**ADDENDUM NUMBER: #2 - 190515**

Project Name: Fire Station #5

## Addendum

198001.000 | Edinburg Fire Station No. 5

EP2.1

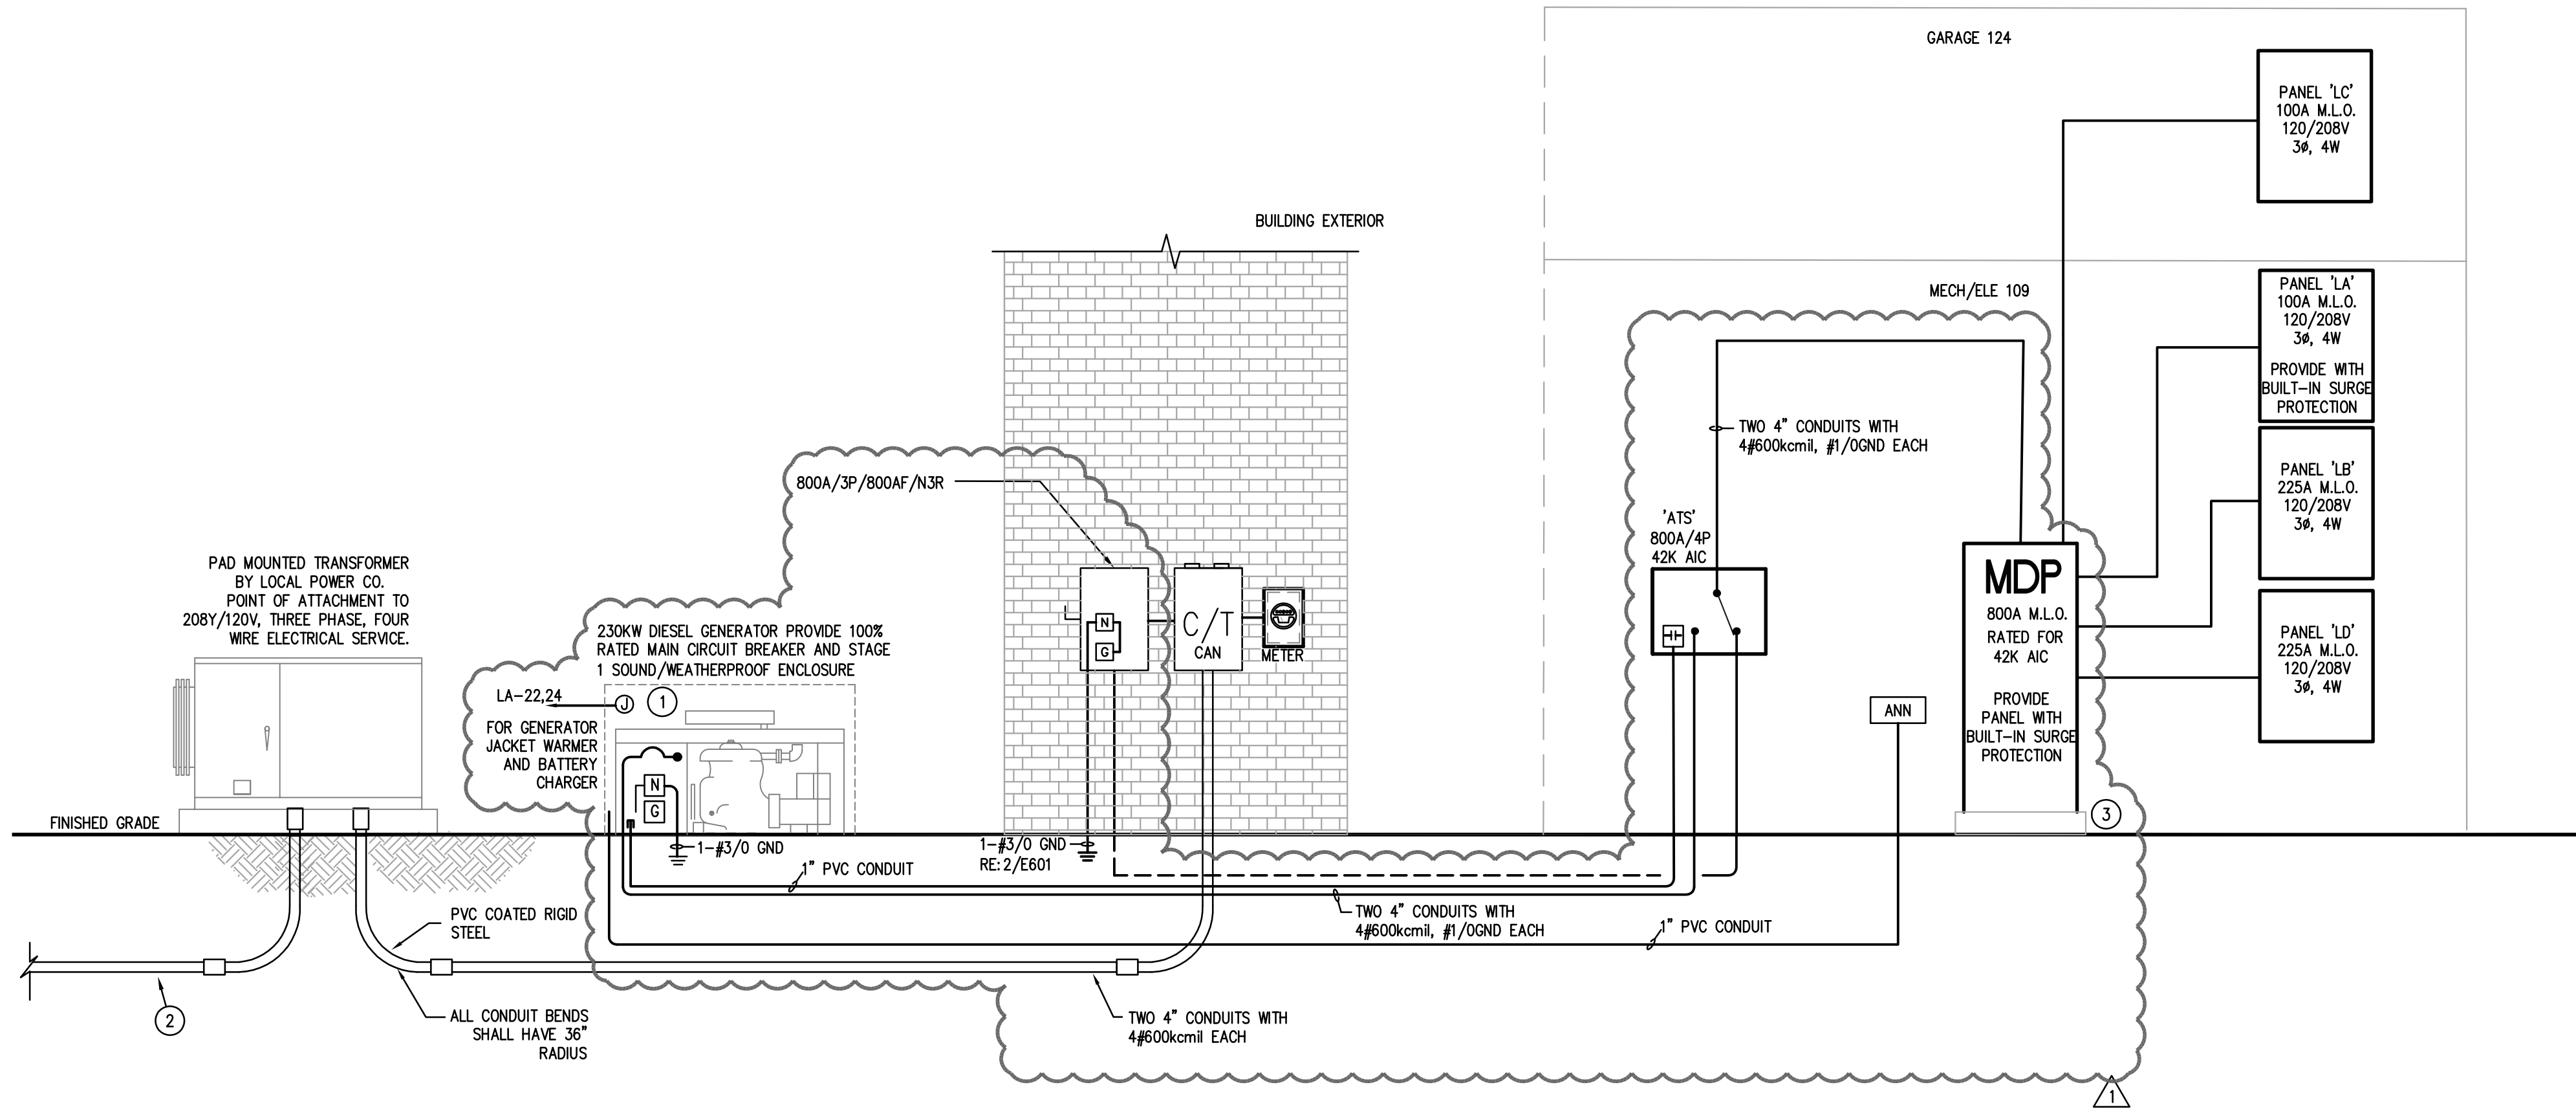
- A.      Provide four new 60A/3P disconnect switches for electric unit heaters in vehicle bay.
- B.      Provide new 208V/3P outlet for electric range in kitchen. Coordinate Nema configuration of receptacle with furnished equipment.
- C.      Provide disconnect switch and circuit to airvac 6.

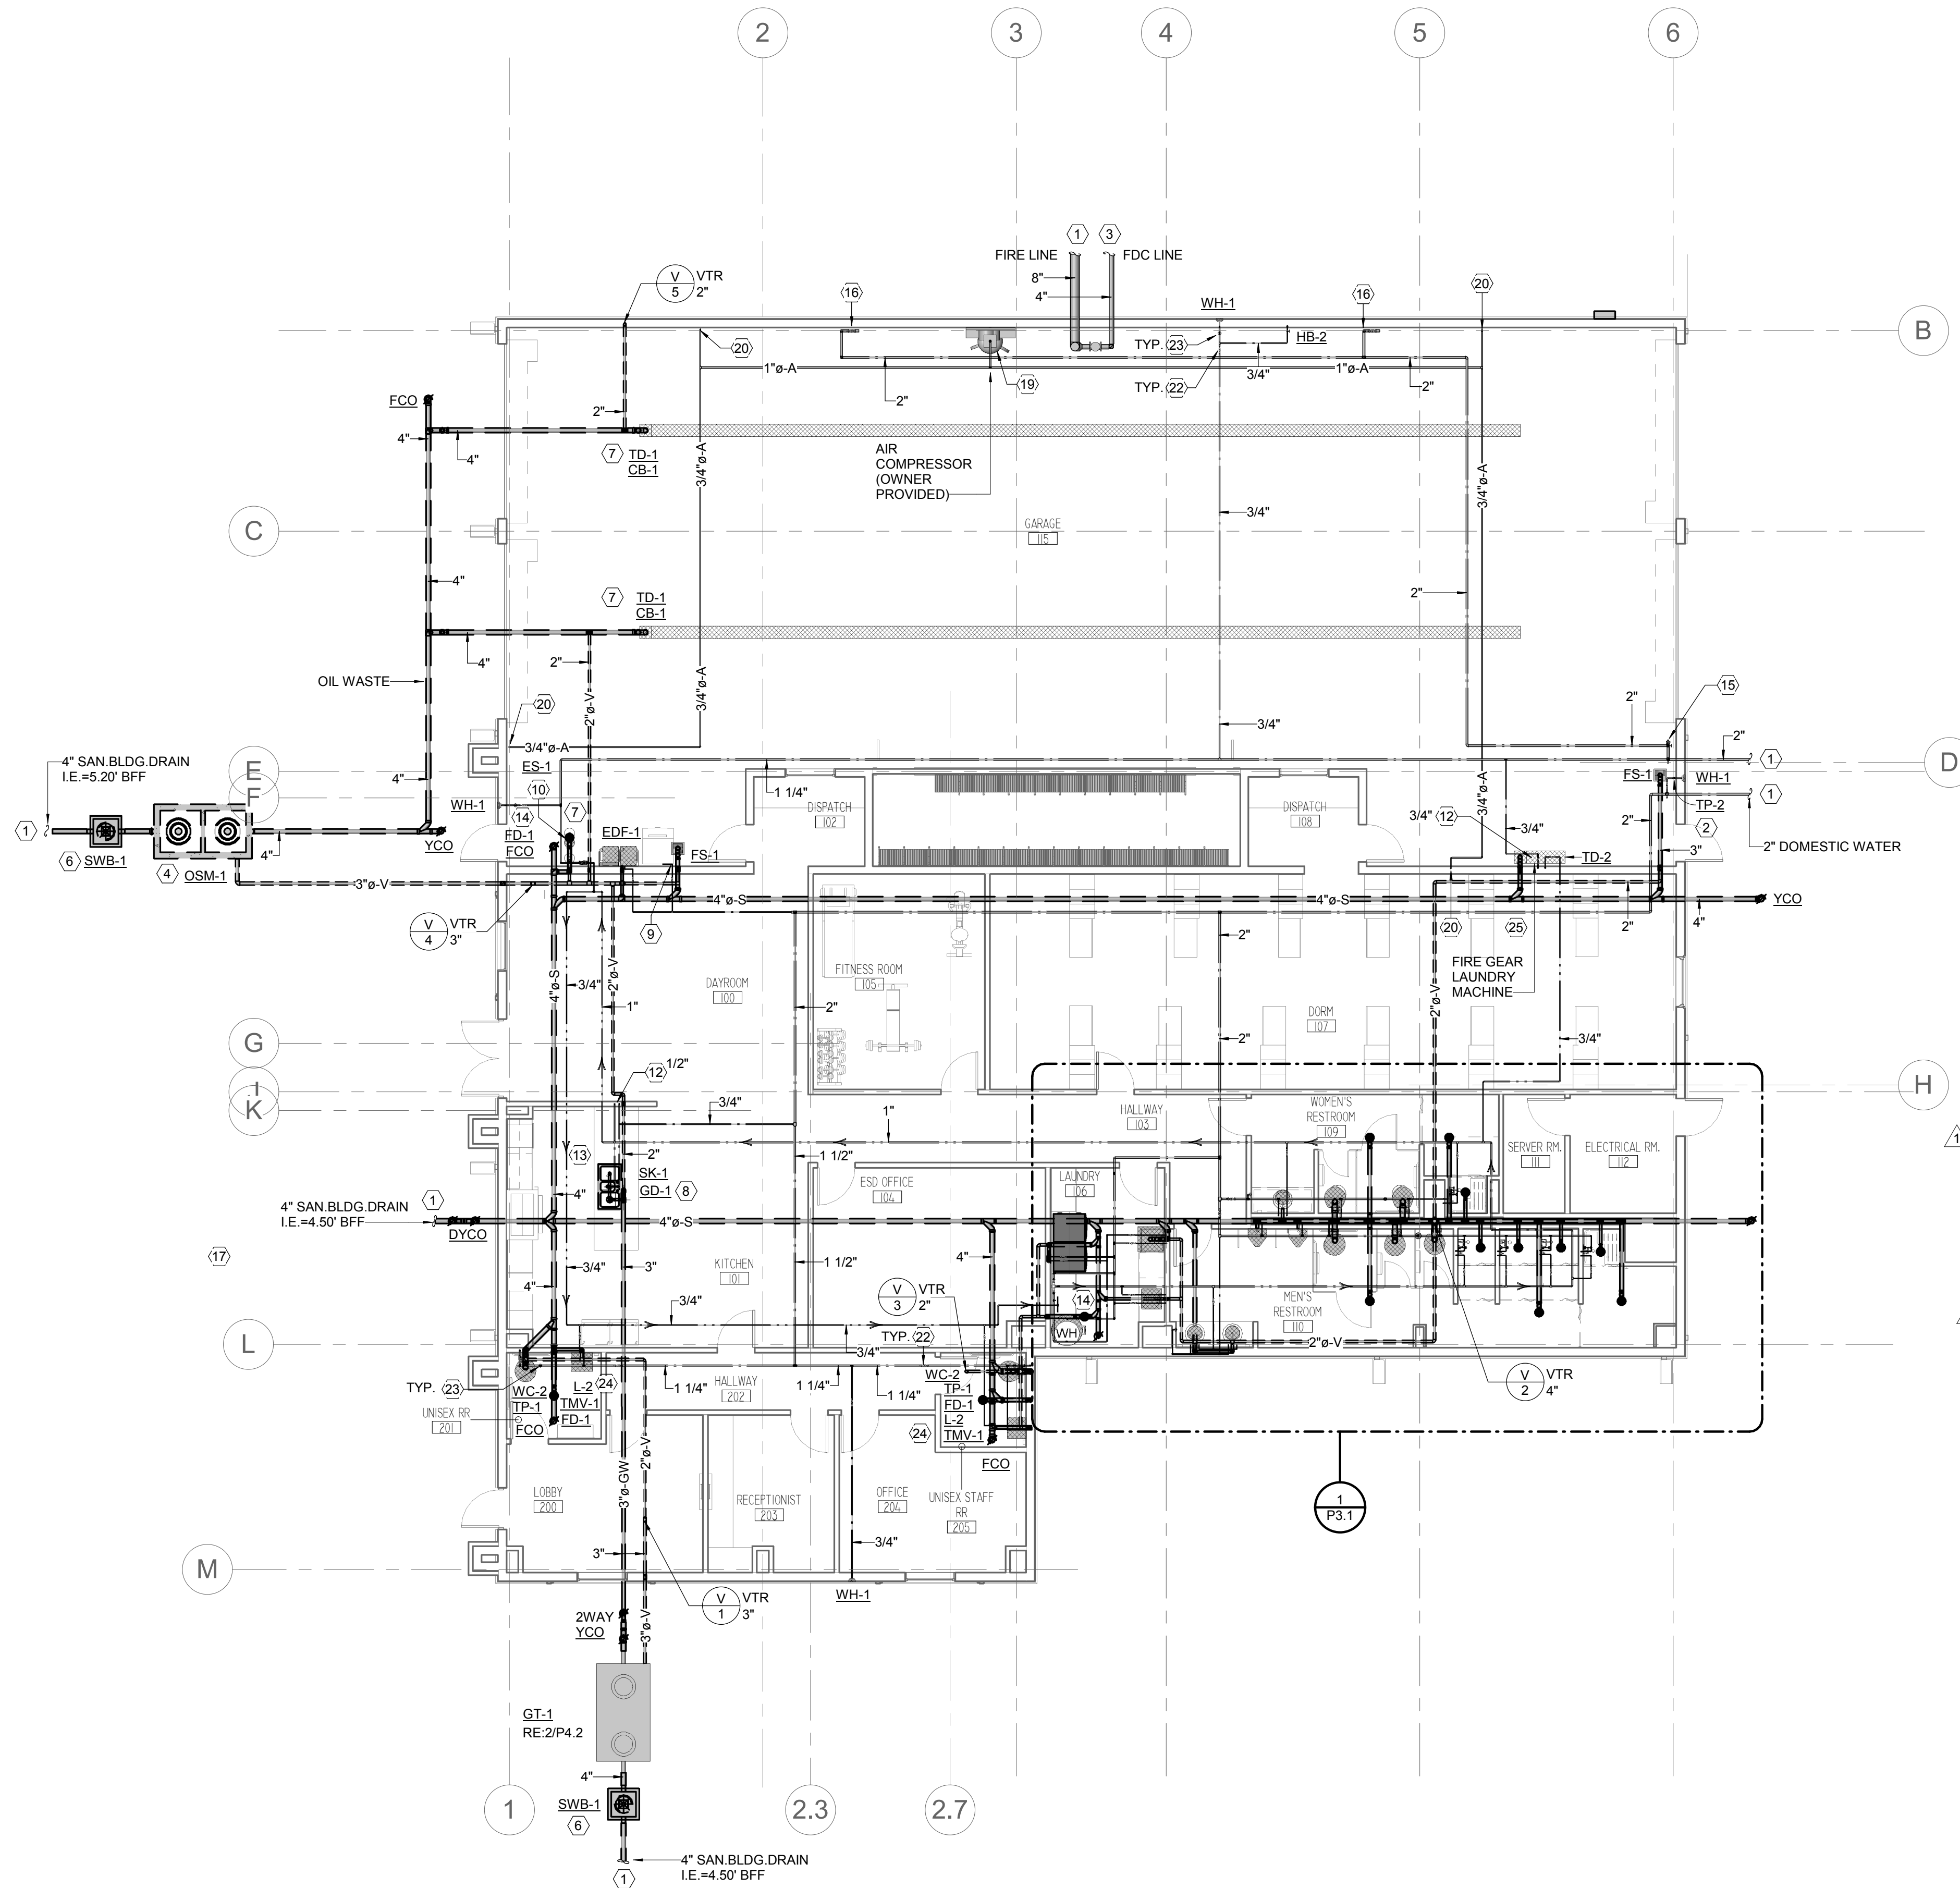
- A.      Provide new 60A/3P breaker in panel LB for new electric range.
- B.      Provide new 20A/2P breaker in panel LD for airvac 6.
- C.      Panel MDP shall be 800 amp.
- D.      Provide four new 60A/3P breakers in panel MDP for electric unit heaters.

**1 PLUMBING FLOOR PLAN**  
P2.1 1/8" = 1'-0"

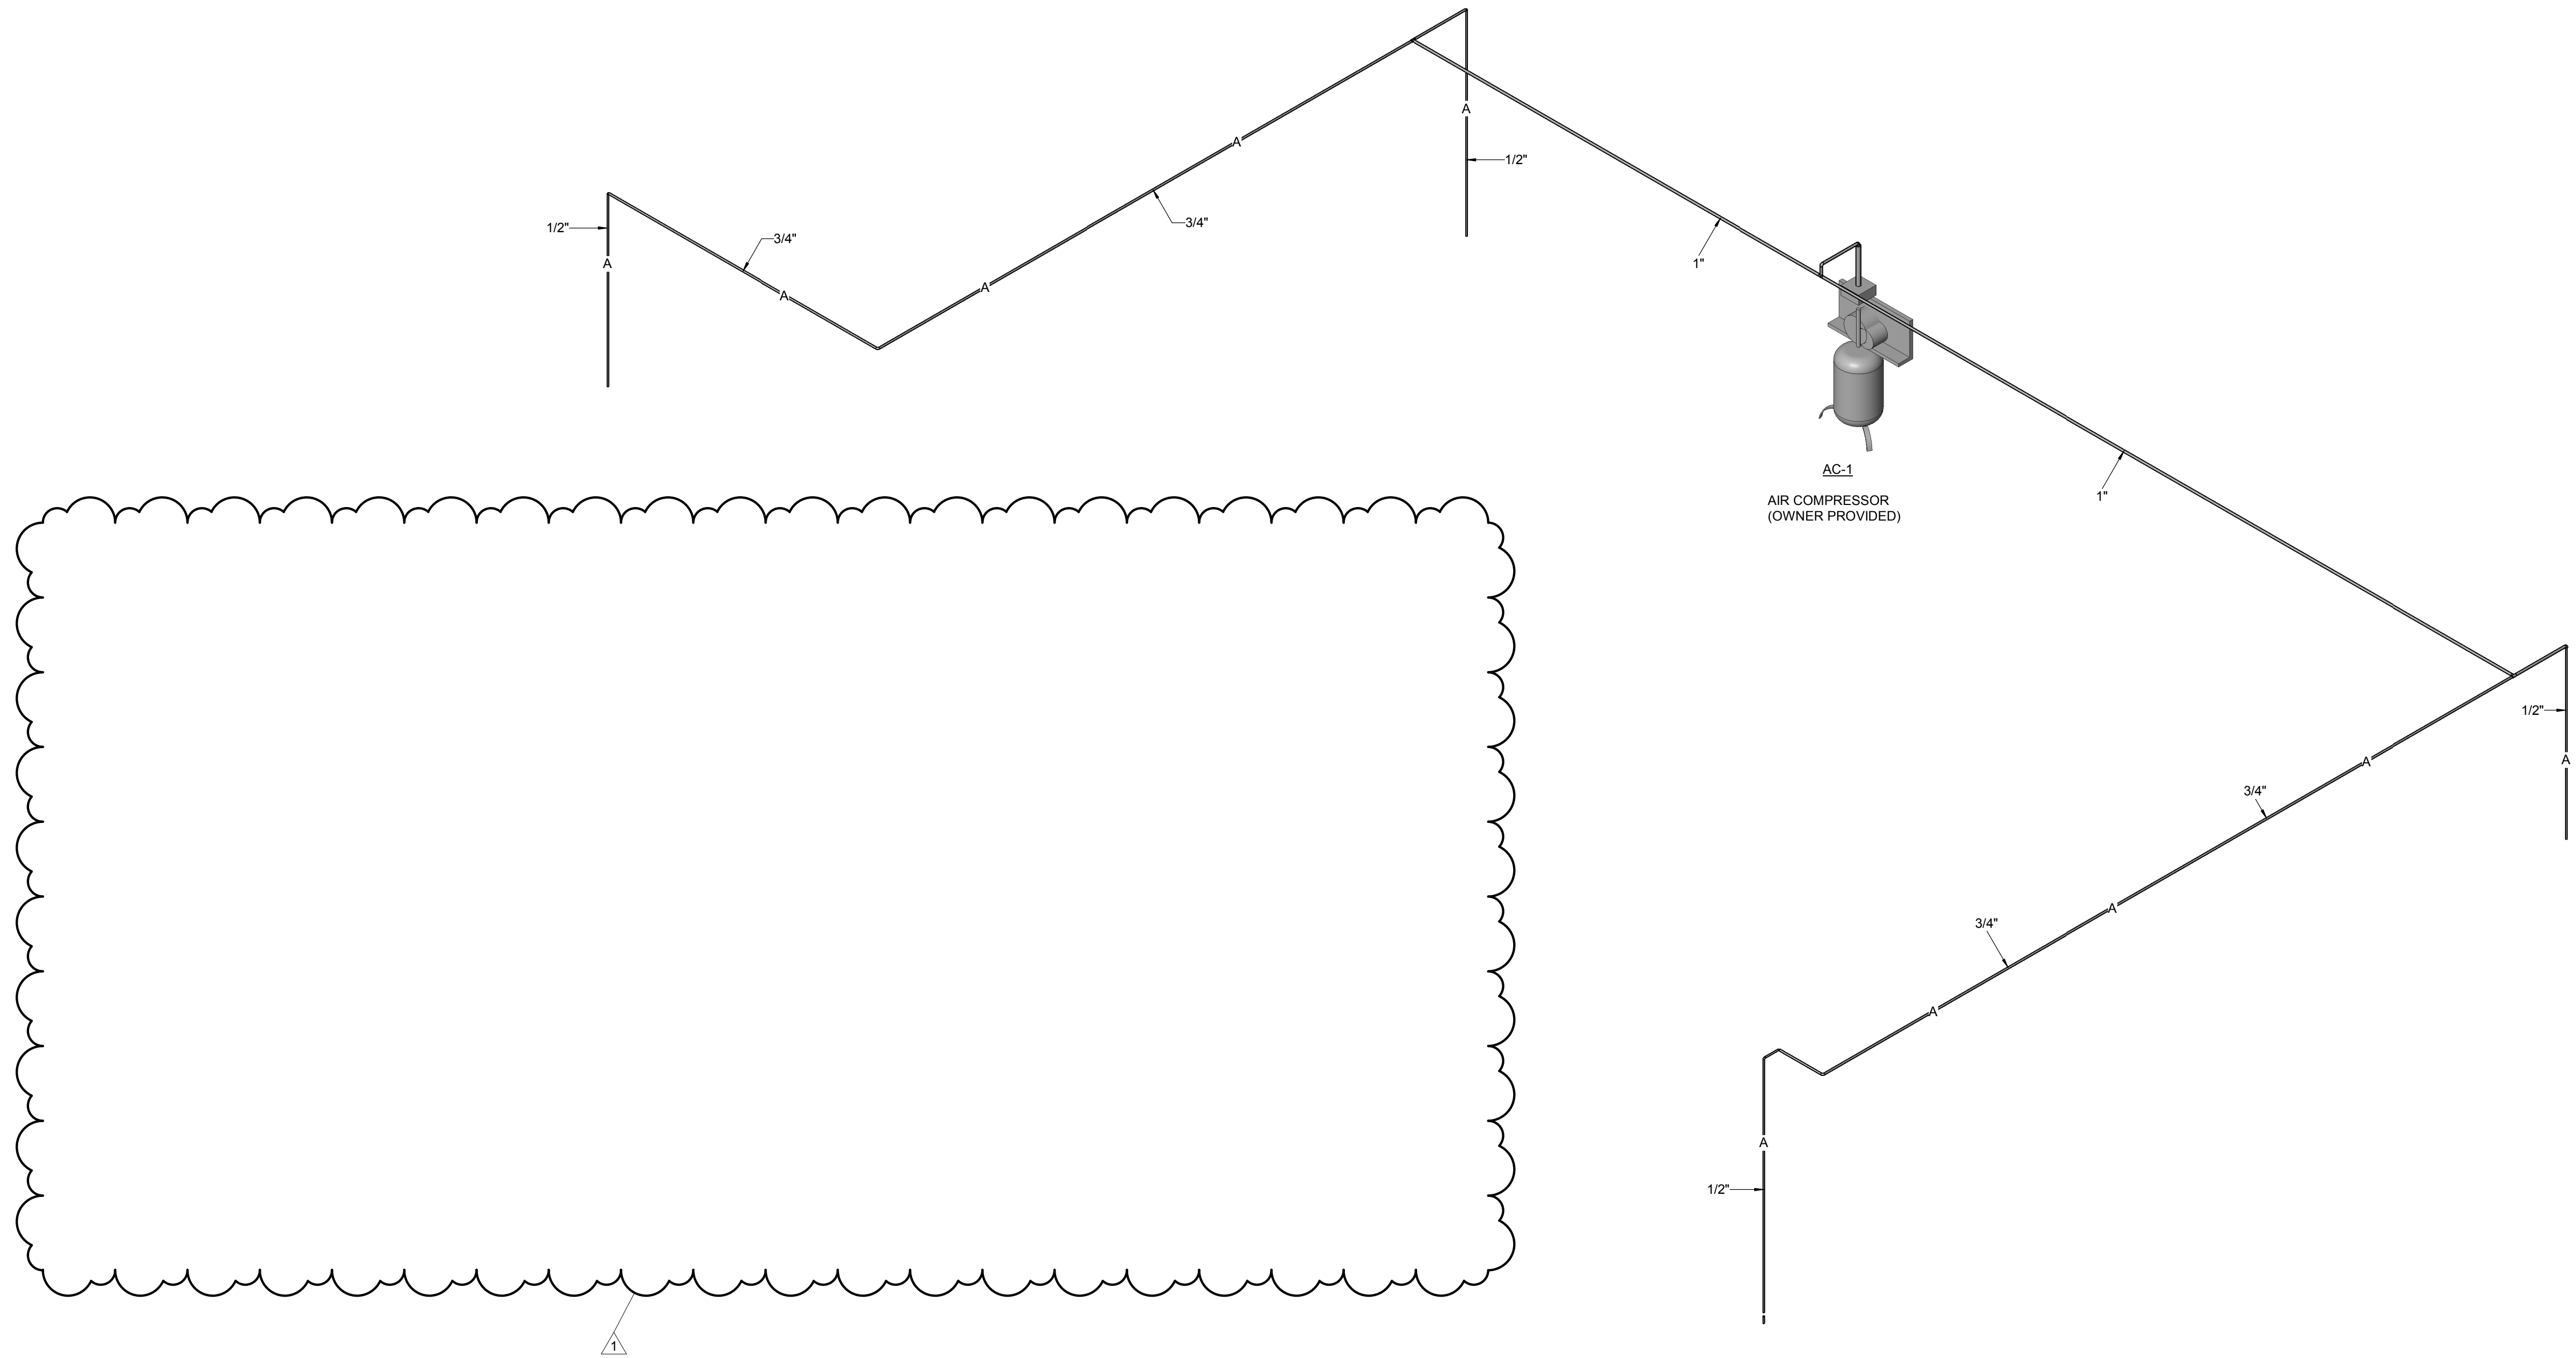
- A.      Natural gas system deleted completely.
